United States Patent and Trademark Office

APPLICATION NO.	FILING DATE	FIRST NAMED INVENTOR	ATTORNEY DOCKET NO.	CONFIRMATION NO	
10/809,390	03/26/2004	John Gross	DFMD-P-040301	3241	
7	590 01/19/2005		EXAMINER		
Peak Innovations Inc.			BURNHAM, SARAH C		
Legal Department 707-777 West Broadway			ART UNIT	PAPER NUMBER	
Vancouver, BC V5Z 4J7			3636	3636	
CANADA			DATE MAILED: 01/19/2005	/19/2005

DETAILED ACTION

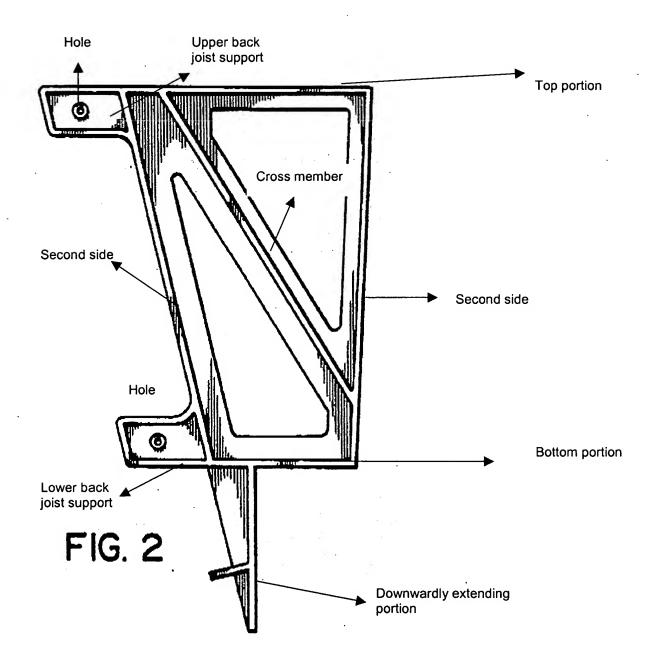
- 6. The following is a quotation of 35 U.S.C. 103(a) which forms the basis for all obviousness rejections set forth in this Office action:
 - (a) A patent may not be obtained though the invention is not identically disclosed or described as set forth in section 102 of this title, if the differences between the subject matter sought to be patented and the prior art are such that the subject matter as a whole would have been obvious at the time the invention was made to a person having ordinary skill in the art to which said subject matter pertains. Patentability shall not be negatived by the manner in which the invention was made.
- 7. Claims 1-8 are rejected under 35 U.S.C. 103(a) as being unpatentable over Smith (D 348,216) in view of Schoenecke (855,817), as best understood with the above cited indefiniteness. The following labeled Figures disclose the claimed elements.

With respect to claims 1 and 5, Smith discloses a seating bracket for connection to a base having a top surface and a vertical side surface to support a seat and a back joist adjacent to the seat, the bracket comprising: a generally horizontal top portion for supporting the seat; a generally horizontal bottom portion for connection to the top surface of the base; first and second generally vertical side portions connected to said top and above paid bottom portion; extending between and bottom portions and supporting said top portion; a first intersecting cross member extending between and connected to said top portion and to said second generally vertical side portion; an upper back joist support portion connected to said first generally vertical side portion adjacent to said top portion for receiving the back joist and holding the back joist in a generally upstanding position, and a lower back joist support portion connected to said first generally vertical side portion adjacent to said bottom portion for receiving the back joist and holding the back joist in a generally upstanding position.

With respect to claims 2 and 6, said lower back joist support portion has a downwardly extending portion below said bottom portion for connection with said vertical side surface of the base.

With respect to claim 3, Figures 3 and 4 disclose holes in the top portion and the bottom portion respectively to facilitate attachment of a seat member and attachment to the support surface. Furthermore, the above labeled Figures disclose the holes formed in the upper and lower back joist support portions.

With respect to claims 4 and 7, the first generally vertical side portion is inclined with respect to vertical and the upper and lower back joist support portions hold the back joist substantially parallel to said first side portion.

With respect to claim 8, said quadrangular portion consisting of the two side portions, top portion and bottom portion in combination with the cores member and upper and lower back joist support portions and the downwardly extending portion are unitary.

Smith reveals all claimed elements with the deception of a second cross member.
